Project	<b>IEEE 802.16 Broadband Wireless Access Working Group</b> < <a href="http://ieee802.org/16">http://ieee802.org/16</a> >	
Title	Remedy of EAP in EAP mode	
Date Submitted	<b>2005-07-14</b>	
Source(s)	Junhyuk Song Jicheol Lee Samsung Electronics	<a href="mailto:junhyuk.song@samsung.com">junhyuk.song@samsung.com</a> <a href="mailto:jicheol.lee@samsung.com">jicheol.lee@samsung.com</a>
Re:	IEEE P802.16e/D9	
Abstract	Remedy of EAP-in-EAP mode Authentication	
Purpose	Adopt this contribution as a remedy of EAP-in-EAP mode	
Notice	This document has been prepared to assist IEEE 802.16. It is offered as a basis for discussion and is not binding on the contributing individual(s) or organization(s). The material in this document is subject to change in form and content after further study. The contributor(s) reserve(s) the right to add, amend or withdraw material contained herein.	
Release	The contributor grants a free, irrevocable license to the IEEE to incorporate material contained in this contribution, and any modifications thereof, in the creation of an IEEE Standards publication; to copyright in the IEEE's name any IEEE Standards publication even though it may include portions of

**Figure 133a- AK with PMK and PMK2  
(EAP-based authorization and Authenticated EAP-based authorization)**

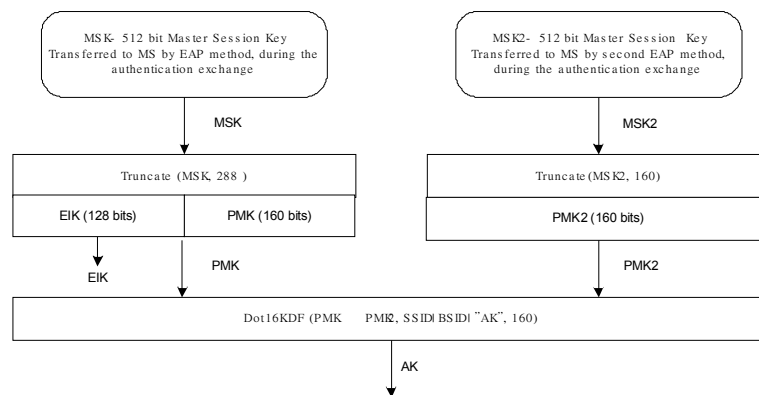
*[Add following figure and text just after figure 133 in page 216 of 802.16e/D9]*

Figure 133a outlines the process to calculate the AK when EAP in EAP mode authentication exchange has taken place, first EAP yielding EIK and MSK and second EAP yielding MSK2.
